Our Ref: Q144007
Our Contact: Mr Dominic Hammersley
Council Ref: 8/13/1481(3693529)

**RESPONSE TO FURTHER ISSUES - RECONFIGURING A LOT
(1 INTO 72 LOTS AND PARK) VIXIES ROAD, WONGA BEACH**

Property Description: Lot 32 on SP126925

Council Reference: 8/13/1481

Figure A1. Culvert Locations

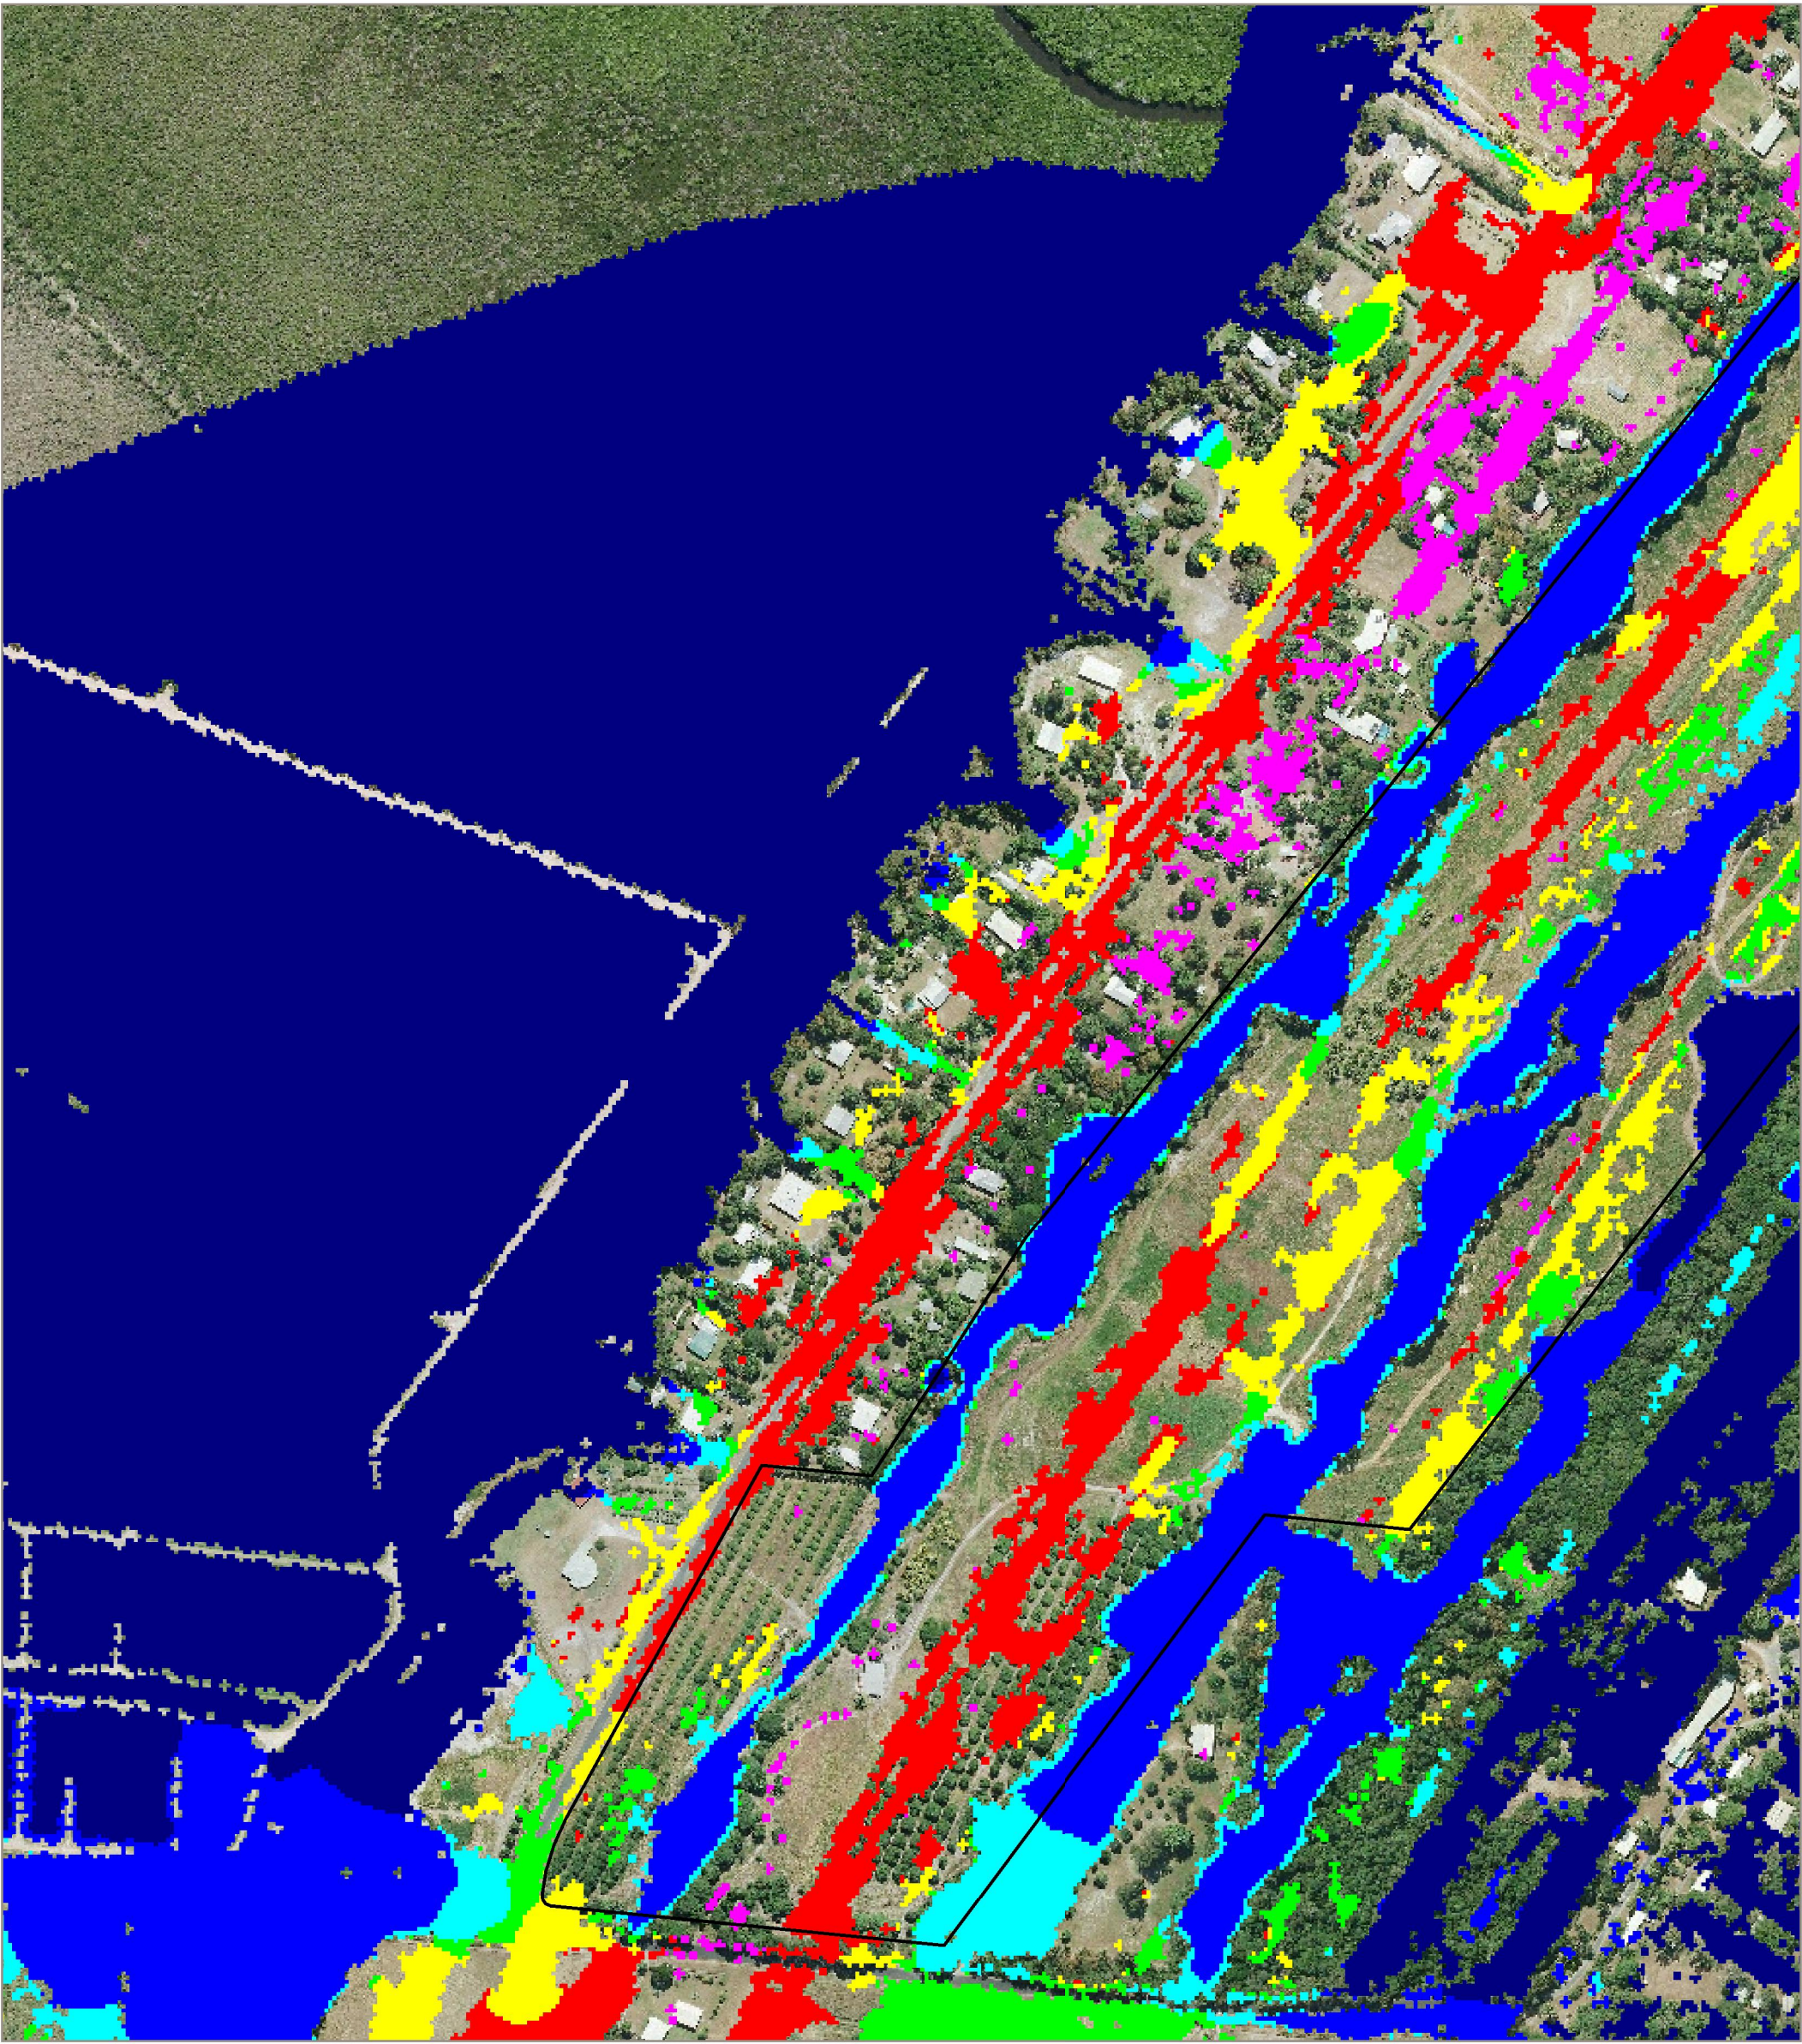
- c., Council's request for detailed survey of swales is not relevant to the extent that the Flood Study appropriately identifies the 100 year ARI flood inundation risk present on each site. Further, there is limited to no discernible 'top of bank' of which to survey. However, survey in relation to existing stormwater culvert infrastructure has been undertaken as detailed at Appendix A of the Flood Study.

Location	Peak Flood Level Existing Conditions (mAHD)	Peak Flood Level Developed Conditions (mAHD)	Change in Peak Flood Level (m)
Upstream of Vixies Road (refer Figure A1 for culvert locations)			
Culvert 1	3.18	3.17	-0.01
Culvert 2	3.89	3.80	-0.09
Culvert 3	4.01	3.98	-0.03
Culvert 4	3.42	3.42	0
Culvert 5	3.36	3.36	0
Downstream of Site			
Western Swale	3.14	3.14	0
Eastern Swale	3.07	3.06	-0.01

CONTOUR AND DRAINAGE PLAN - SHEET 2 OF 3
SCALE 1:1000

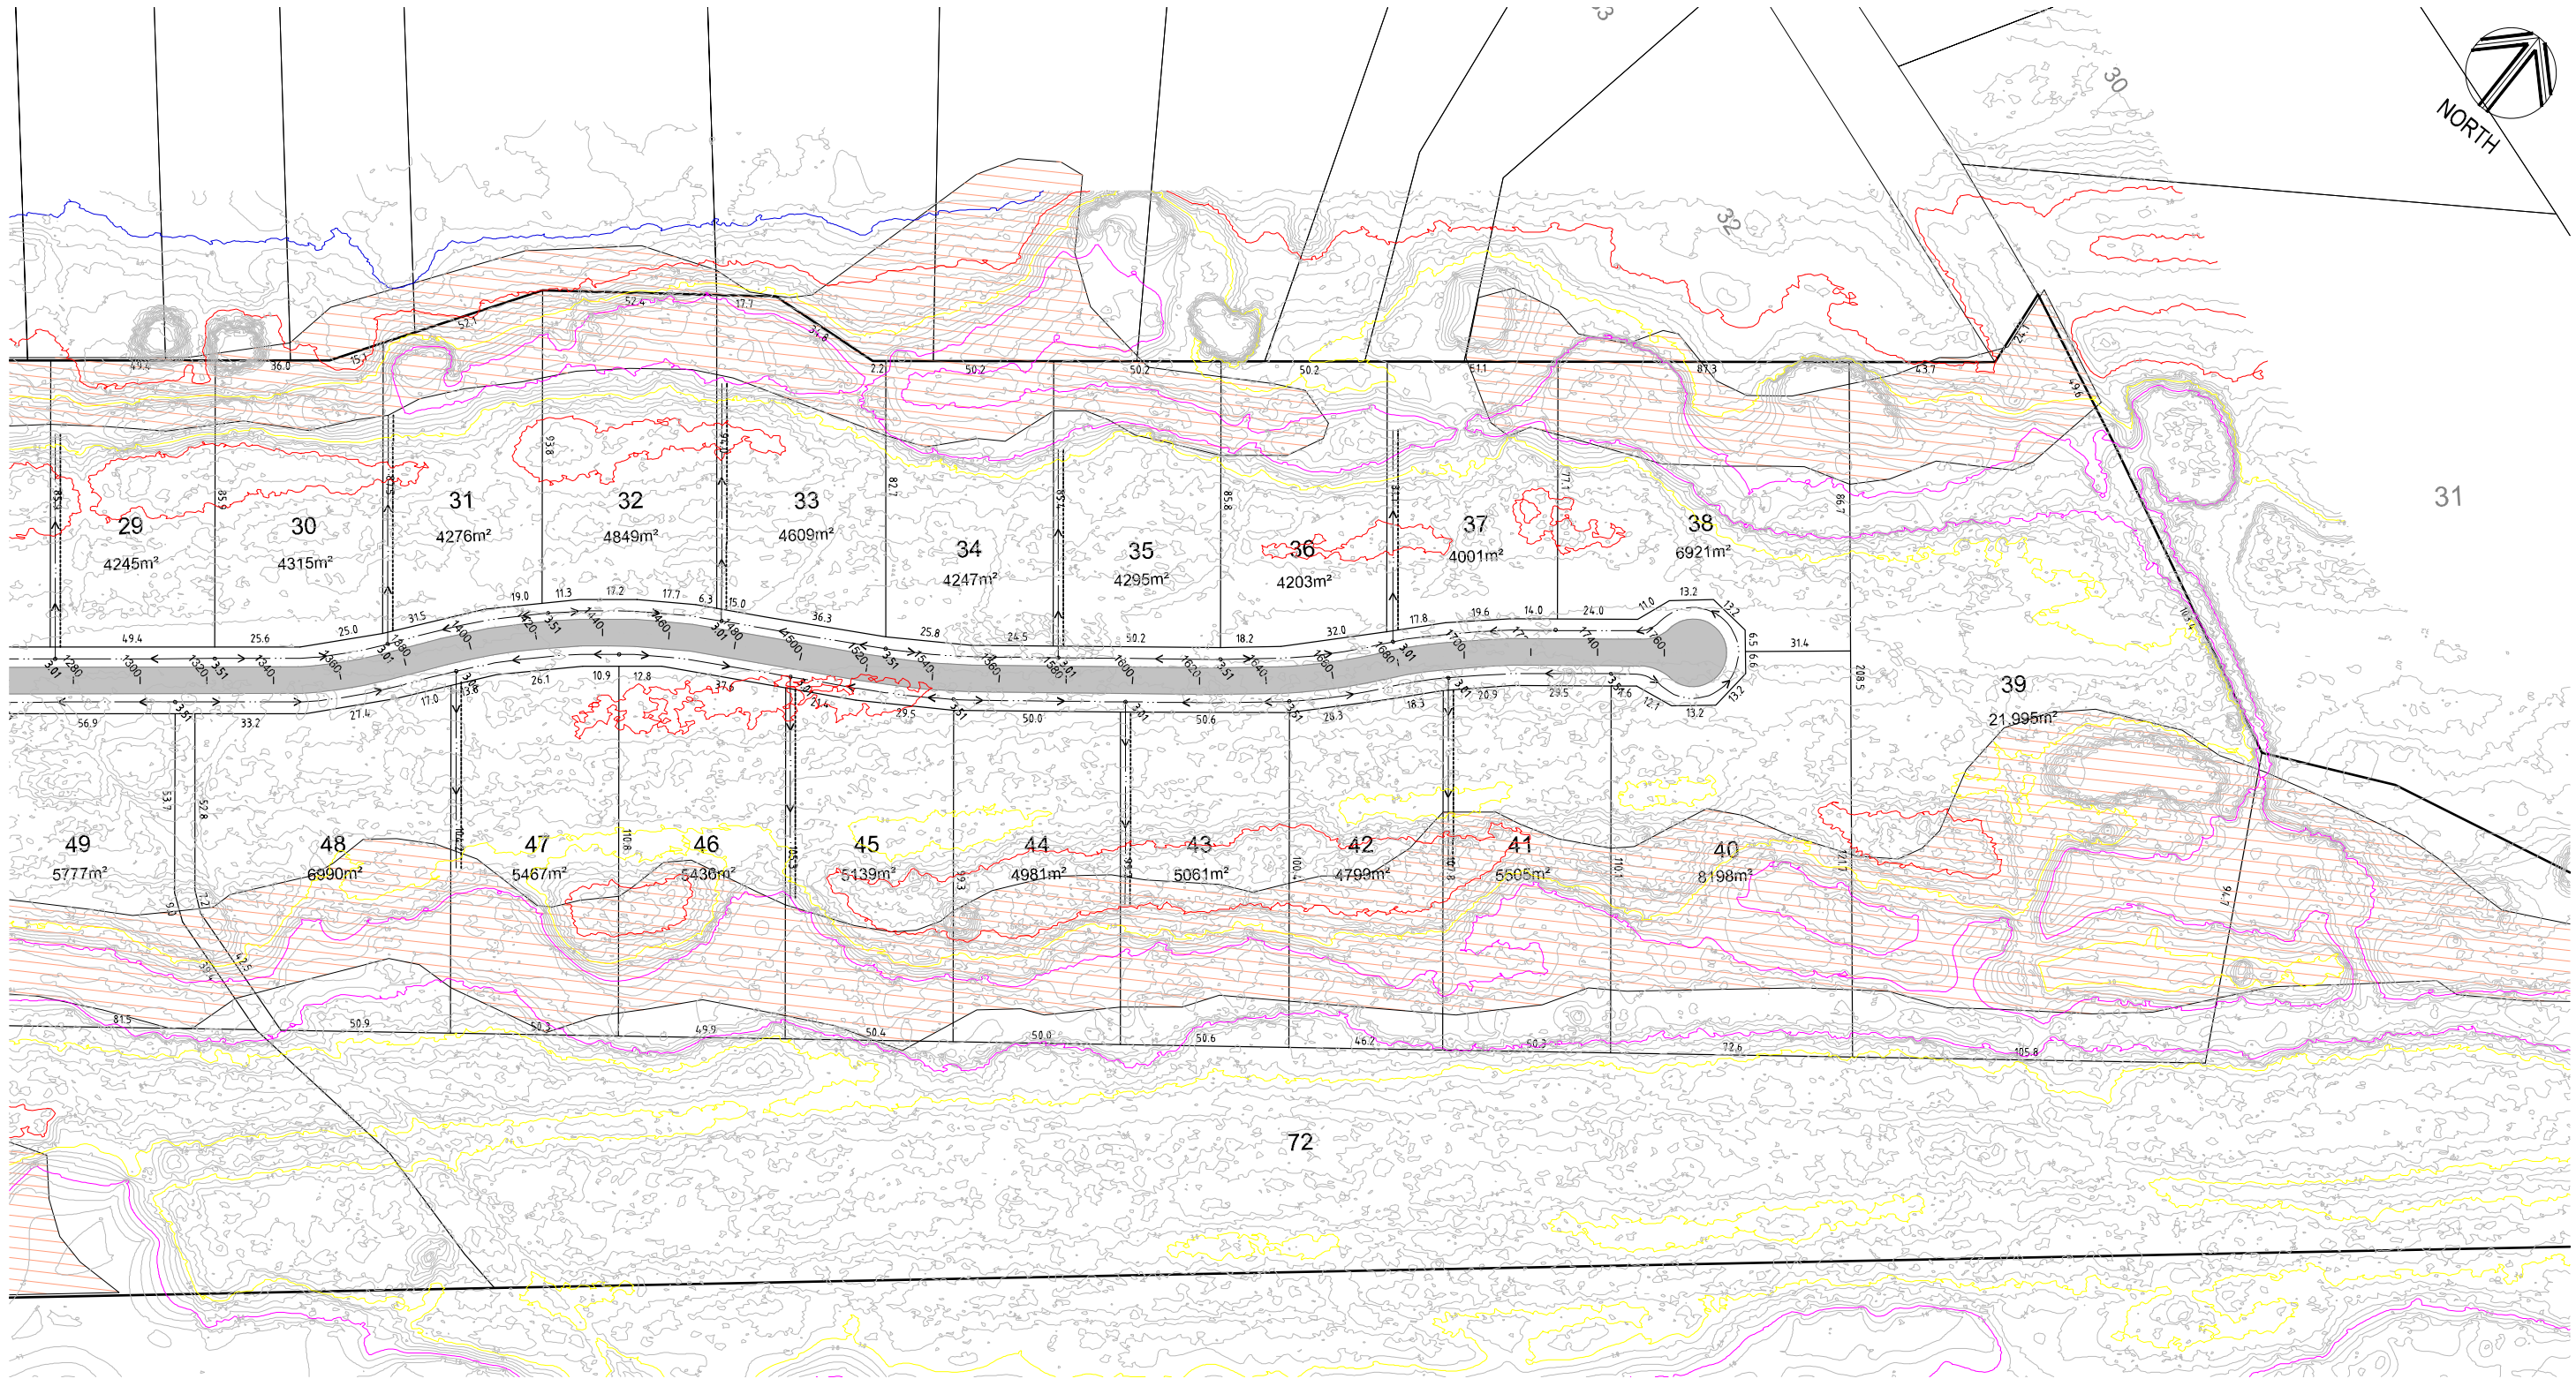
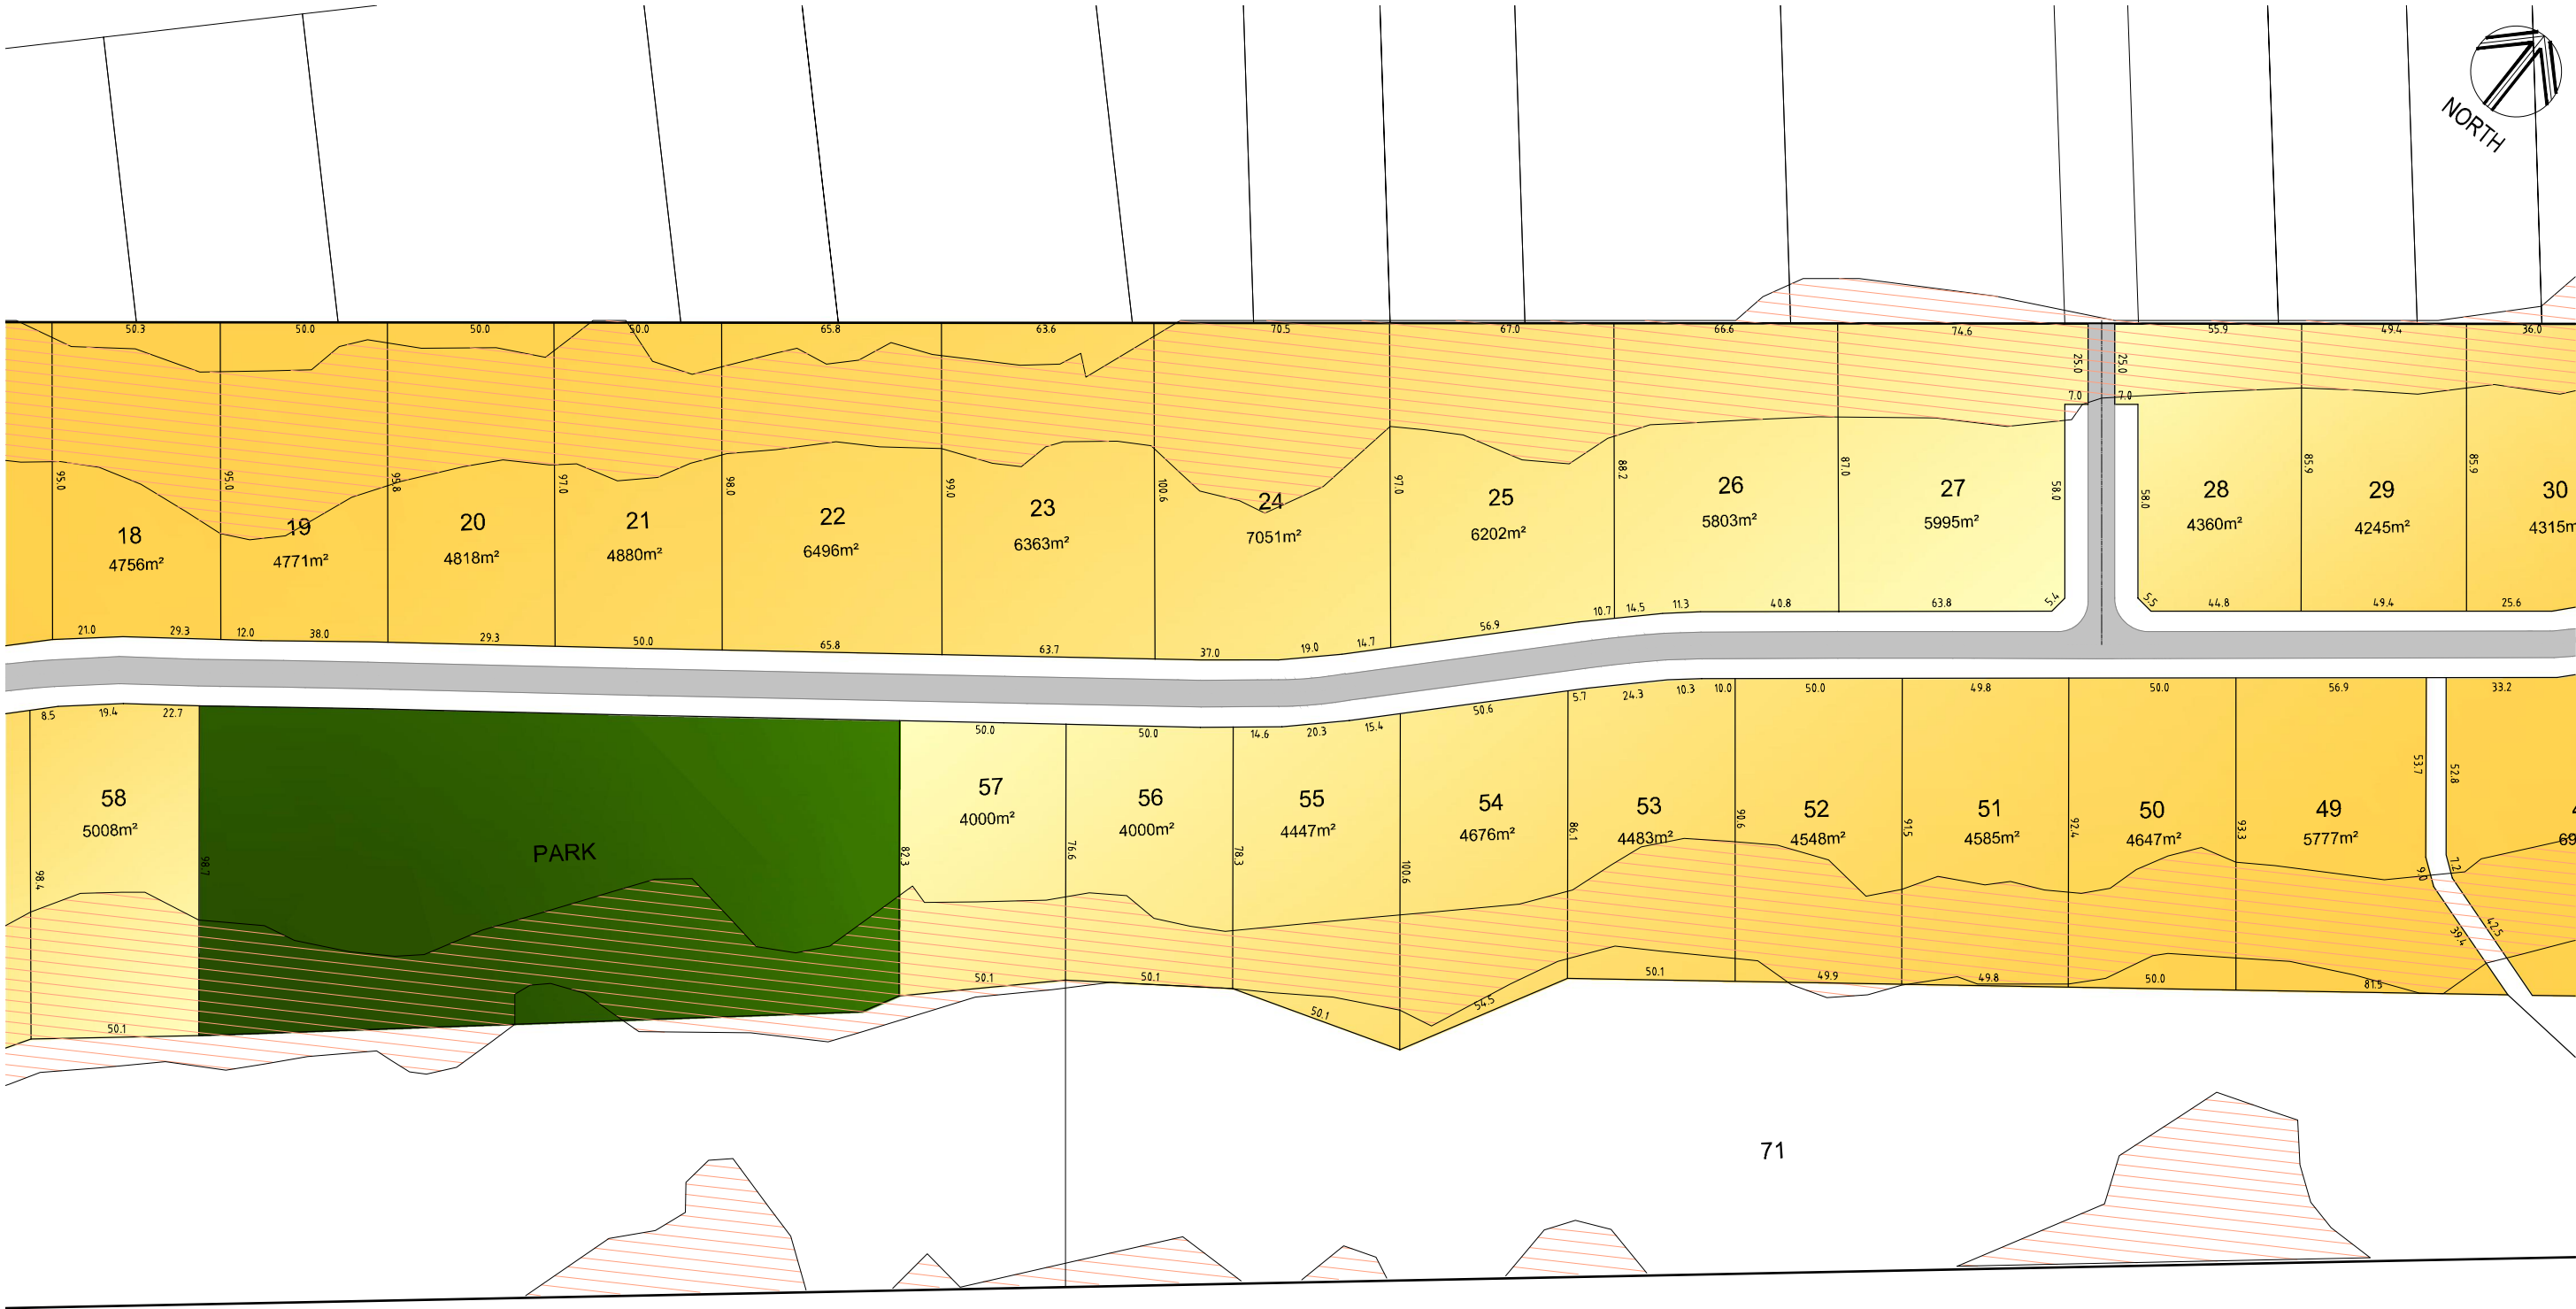
- f., drainage channels are identified on proposed lots 6, 9, 11, 13, 15, 17, 19, 21, 23, 25, 27, 29, 31, 33, 35, 37, 41, 43, 45, 47, 49, 51, 53, 55, 58, 60, 62, 64, 66 and 68 (refer Appendix D of the Flood Study). These proposed drainage channels discharge to the existing natural waterways at the rear of the proposed lots. Existing natural waterways are not considered appropriate to be identified as drainage easements as vegetation within these waterways is to be retained. Vegetation retention is not considered conducive to the maintenance of these areas as drainage easements *per se*. However, drainage channels described at 'f.' (above) are to be formalised as proposed drainage easements in the Operational Works development application stage. Formalisation of drainage easements as part of the Operational Works stage is appropriate as this more detailed design will identify the exacting width of drainage easements in order to ensure that drainage easements are of an appropriate width necessary to convey stormwater at specified locations¹. It is considered that access for the maintenance of drainage channels is to be provided within drainage easements i.e. drainage easements will be provided with an additional area sufficient for maintenance vehicles to access parallel to drainage channels.

Survey of the site was obtained from Lidar data provided by the Department of Natural Resources and Mines. The top of bank of the swales is evident from the flood mapping provided in Appendix B and Appendix C. In addition, the extent of the existing vegetation along the swales is shown in the Drawings in Appendix D. The results in Appendix C demonstrate that all lots have adequate space to include appropriate setback distances to future building envelopes from the top of bank of the drainage swales. Drawings showing existing contours and the revised lot layout are also contained in Appendix D.
